Access Compliance Report

Public Rights-of-Way

(Curb Ramps)

Intersection ID: 10035097	Main Street: PROVIDENCE_RD	Cross Street: N/A	Location: NE
ADA ID: 395EAC7E7AB8	Ramp Type: BlendTrans1	Initial Pass/Fail: Fail	Overall Compliance: No
Codes/Mitigation Info/Possible Solution		Field Measurements/Component Compliance	
Severity Score: 1.25

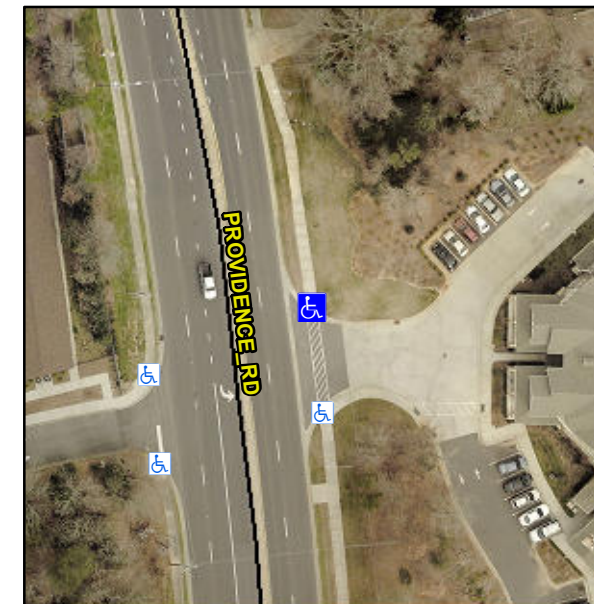
Not Found, R304.5.3

Compliance	Description	Data	Compliance	Description	Data
N/A	Ramp Length (in)	47.0	Yes	BlendTrans Slope (%)	1.0
Yes	Ramp Width (in)	72.0	No	BlendTrans XSlope (%)	2.9
N/A	Flare Type LT	N/A	N/A	Flare Type RT	N/A
N/A	Flare Slope LT (%)	N/A	N/A	Flare Slope RT (%)	N/A
N/A	Flare Traversable LT?	N/A	N/A	Flare Traversable RT?	N/A
N/A	Landing Length (in)	N/A	N/A	DWS Provided?	N/A
N/A	Landing Width (in)	N/A	N/A	DWS Contrast?	N/A
N/A	Landing Slope (%)	N/A	N/A	DWS Length (in)	N/A
N/A	Landing X Slope (%)	N/A	N/A	DWS Full Width?	N/A
N/A	Landing Curb? (Y/N)	N/A	N/A	DWS Offset (in)	N/A
N/A	Shared Landing?	N/A			
N/A	Gutter Ponding?	N/A	N/A	Gutter Slope (%)	N/A
N/A	Gutter Lip Ht (in)	N/A	N/A	Gutter X Slope (%)	N/A
N/A	Painted X Walk1?	Yes	N/A	Painted X Walk2?	N/A
	X Walk 1 Direction	To S		X Walk 2 Direction	N/A
	X Walk 1 Width (in)	66.0		X Walk 2 Width (in)	N/A
	X Walk 1 Slope (%)	2.5		X Walk 2 Slope (%)	N/A
	X Walk 1 X Slope (%)	1.3		X Walk 2 X Slope (%)	N/A

N/A	Ramp inside XWalk1?	Yes	N/A	Ramp inside XWalk2?	N/A
	Road Slope (%)	1.3		Clear Space?	N/A
	Road X Slope (%)	2.5	N/A	Clear Space to XWalk (in)	N/A
N/A	Any Obstructions?	N/A	N/A	Storm Grate/Utility Hazard?	N/A
	Obstruction Type			Storm Grate/Utility Type	
		N/A			N/A
			Yes	Surface Condition? (G/P)	Good
			No	Curb Slope (%)	6.5

Remove & Replace Curb Ramp With Two New Directional Ramps or Equivalent.
